INDICATING/RECORDING SYSTEMS - COLLINS ENVIRONMENTAL CONTROLLER (IEC) AND POWER SUPPLY (PWR) IAPS MODULES INSPECTION/REPLACEMENT

MTL-31-01  
Page 1 of 3

**SUBJECT:** INDICATING AND RECORDING SYSTEM - IEC-X00X - REPLACEMENT OF LOW RELIABILITY TRANSISTORS

**SUBJECT:** INDICATING AND RECORDING SYSTEM - PWR-X00X - REPLACEMENT OF LOW RELIABILITY TRANSISTORS

Transistor Q1 and Q2 Location Diagram  
Figure 1

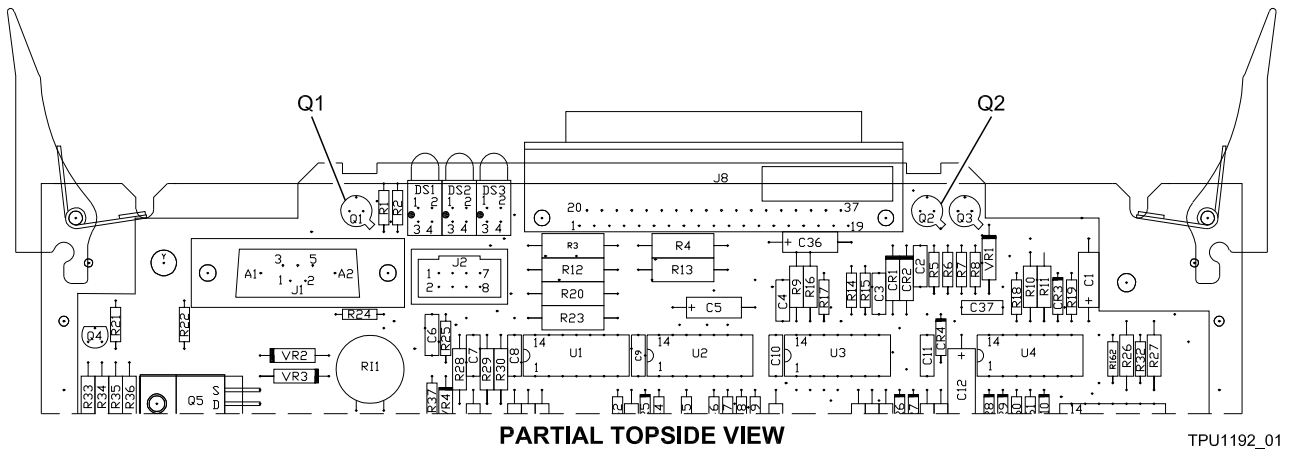
- (2) Refer to Figure 1, locate transistor Q1 and Q2 on the IEC-3001 Environmental Control Card A1, CPN 687-0894-001.

- (3) If either transistor Q1 or Q2 has a date code of 2119, or is not visible, continue to Step 3.A.(3)(a). If the date code on both transistor Q1 and Q2 is not 2119, proceed to Step 3.A.(4).

- (a) Remove conformal coat from around component(s) to be replaced in accordance with the General Repair Procedures in the referenced CMMPL.
- (b) Locate, remove, and discard transistors Q1 and/or Q2. Install new transistors Q1 and/or Q2, CPN 352-0551-010. Ensure the new transistor, CPN 352-0551-010, does not have a date code of 2119.

- NOTE:** Only replace resistors Q1 and/or Q2 if it has a date code of 2119, or if the date code is not able to be read. If only one (1) component has the date code of 2119, only the affected component needs to be replaced.

- (c) Reapply conformal coat in accordance with the Repair Procedures in the referenced CMMPL around replaced component(s).
- (4) If MOD chart is not already on the circuit card, cut the word MOD and seven (7) squares from MOD chart, CPN 280-3778-050. Remove protective backing, then apply MOD chart to circuit card.

- (5) Use permanent ink to mark SB A on the MOD chart.
- (6) Reassemble the unit in accordance with the assembly instructions in the Assembly section of the referenced CMMPL.

PWR-3000 or PWR-4000, Power Supply Circuit Card A1, CPN 687-0896-001, Component Location Diagram  
Figure 1

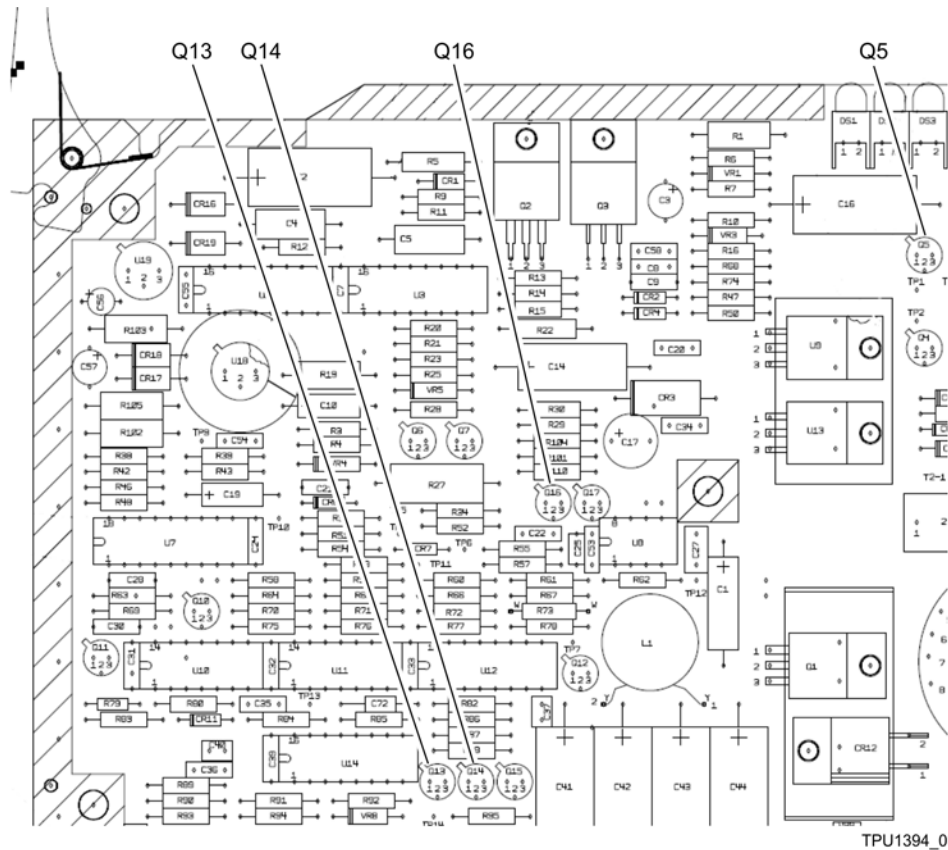
- (2) Using Figure 1, locate transistors Q5, Q13, Q14, Q16 on the PWR-3000 or PWR-4000 Power Supply Circuit Card A1, CPN 687-0896-001.

- (3) Refer to Figure 1. If transistors Q5, Q13, Q14, or Q16 have a date code of 2119 or is not visible, proceed to Step 3.A.(3)(a). If the date code on transistors Q5, Q13, Q14, and Q16 is not 2119, proceed to Step 3.A.(4).
- (a) Remove conformal coat from around component(s) to be replaced in accordance with the General Repair Procedures in the referenced CMMPL.
  - (b) Locate, remove, and discard any 2119 date coded transistors amongst transistors Q5, Q13, Q14, Q16. Replace any removed 2119 date coded transistors with new non-2119 date coded transistors, CPN 351-0551-010.

**NOTE:** Only replace 2119 date coded transistors, or if the date code is not able to be read. If only one (1) component has the date code of 2119, only the affected component needs to be replaced.

- (c) Reapply conformal coat in accordance with the Repair Procedures in the referenced CMMPL around replaced component(s).
- (4) If MOD chart is not already on the circuit card, cut the word MOD and 10 squares from MOD chart, CPN 280-3778-050. Remove protective backing, then apply MOD chart to circuit card.
- (5) Use permanent ink to mark SB B on the MOD chart.
- (6) Reassemble the unit in accordance with the assembly instructions in the Assembly section of the referenced CMMPL.
